SUBDIVISION REVIEW SHEET

CASE NO.: C8-2021-0078.1A

SUBDIVISION NAME: Cearley Community Subdivision

CITY OF AUSTIN –DEVELOPMENT SERVICES DEPARTMENT
SUBDIVISION APPLICATION – MASTER COMMENT REPORT

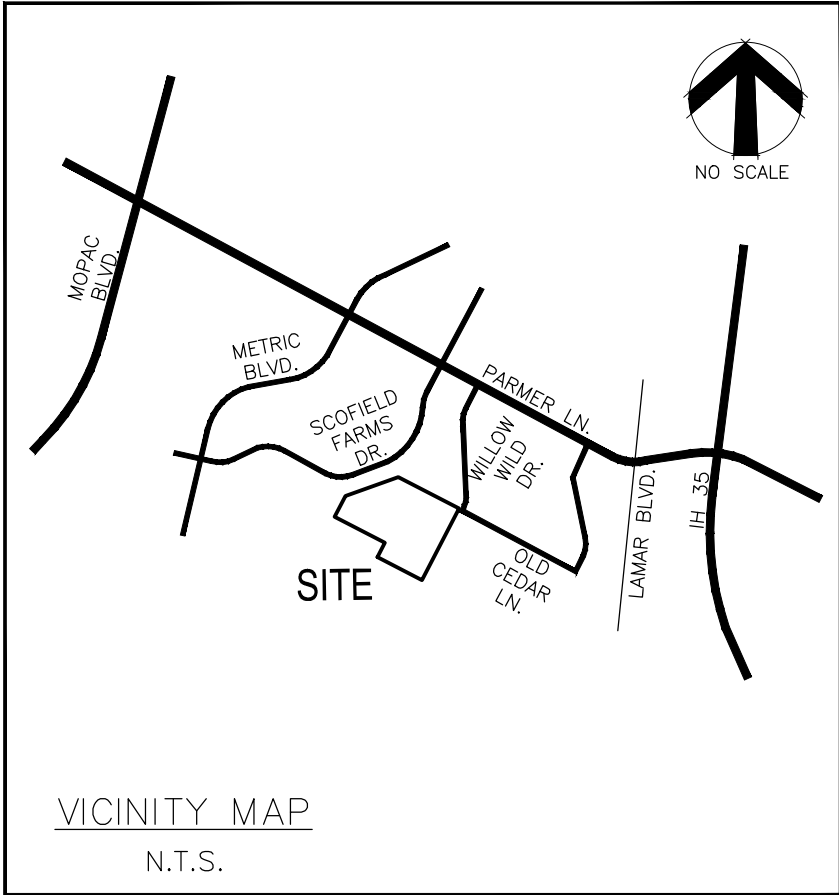
SR 1. The plat diagram should be the first page. The plat notes and signatures should be on the second page. 25-1-83

SR 2. Add the Case #C8-2021-0078.1A in the bottom right hand corner of each sheet. 25-1-83

SR 3. Revise the owner's dedication block as follows: 25-1-83, TX LGC 212.004(c)

SR 4. Revise the recordation block as shown: 25-1-83

SR 5. Amend the Land Use Commission approval block. 25-1-83:

SR 6. Revise the engineer's certification 25-1-83

SR 7. Amend plat note 12 to the following note 25-1-83 and 25-2: "Building setback lines shall be in conformance with City of Austin zoning ordinance requirements."

SHEET
1
OF 3

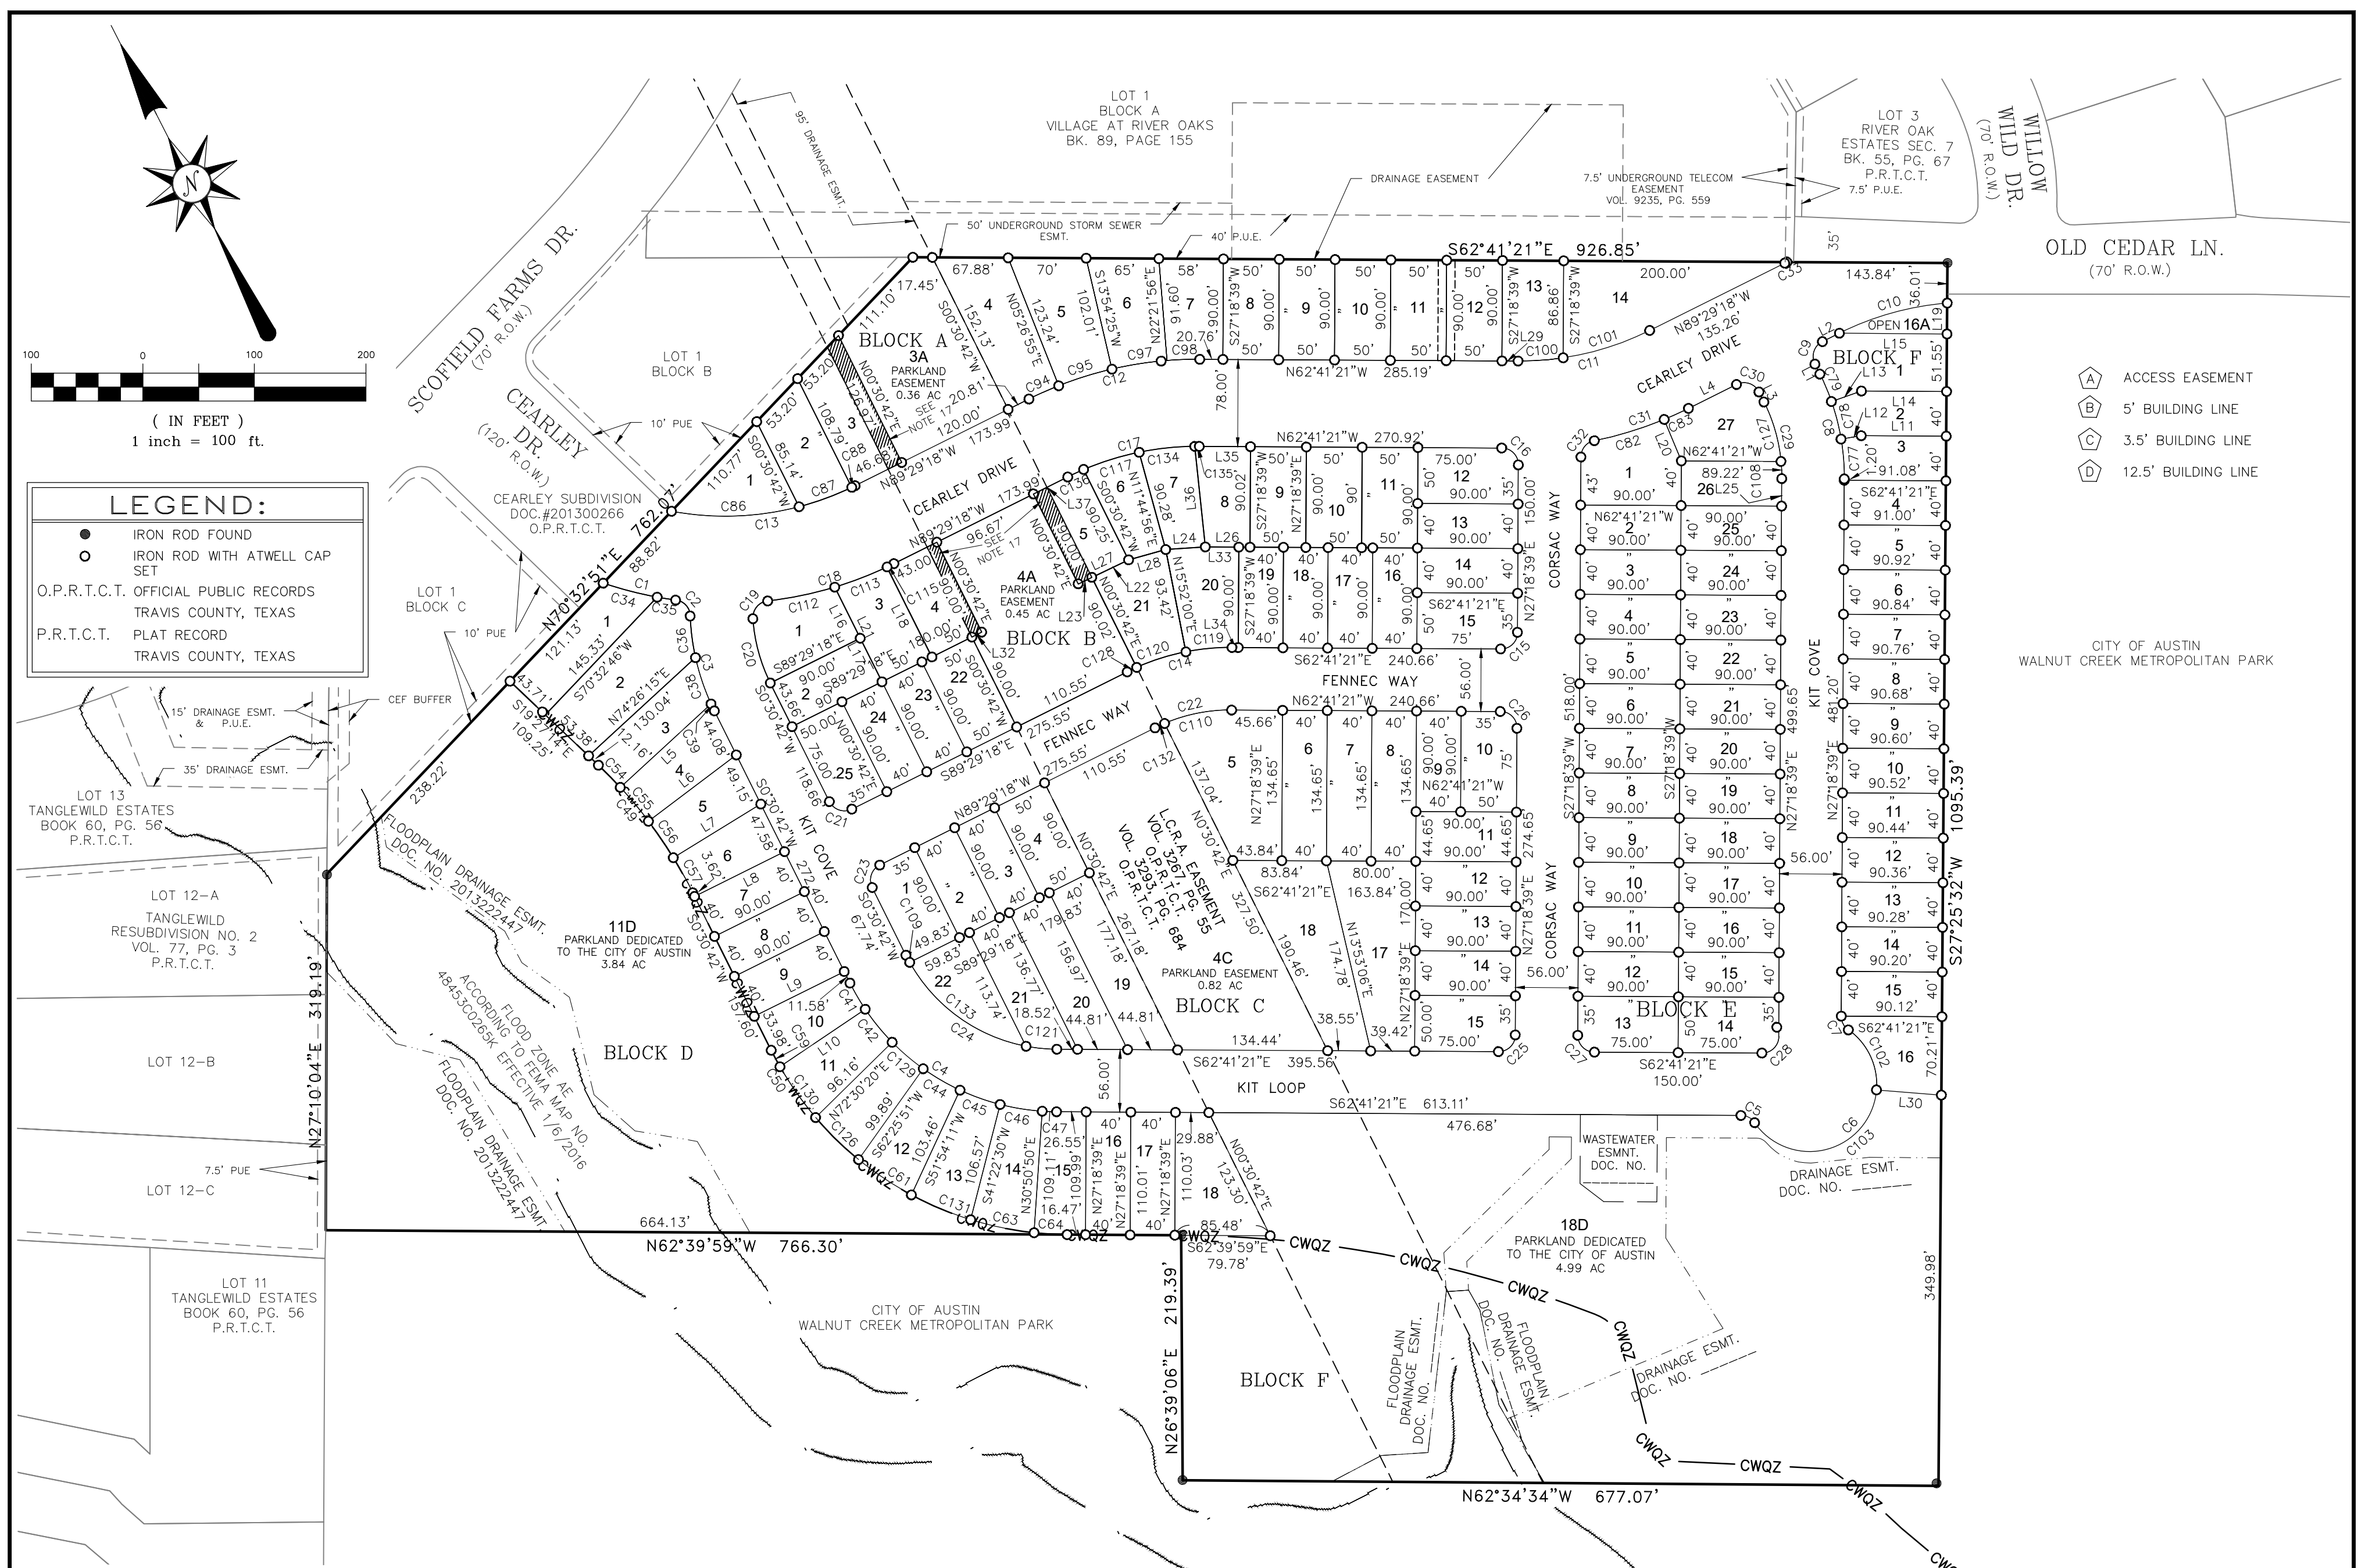
Fifteen (15') foot electric distribution, electric telecommunications, and electric fiber easement is required adjacent to Cearly Drive R.O.W.

Ten (10') foot electric distribution, electric telecommunications, and electric fiber easement is required adjacent to all other street R.O.W. Show the easement(s) on the face of the plat.

AD2: KIT LOOP street type should be CIRCLE as layout meets criteria

NOTE1: Please change street type label to CIRCLE

EV 2 Remove critical water quality zone buffers from the plat.

FP1: Easement must be dedicated to contain the 100-year floodplain per LDC 25-7-152 and LDC 30-4-152. Please delineate the location of easement on plat. Easement can be dedicated either via separate instrument or via plat.

- A. Please remove the proposed detention pond areas from the parkland.

Remove the lift station wastewater easement. This will be dedicated by separate instrument during construction plan phase, not by plat.

WB# Pursuant to LDC 25-8-282(A), please show the location and boundaries of the wetland CEF identified by City Staff on November 30, 2021 as "Wetland CEF".

2. Sidewalks are required on both sides of Cearly Drive, Corsac Way, Fennec Way, and Kit Loop. Identify the location of the sidewalks by a dotted line on the final plat. [LDC 25-6-351]
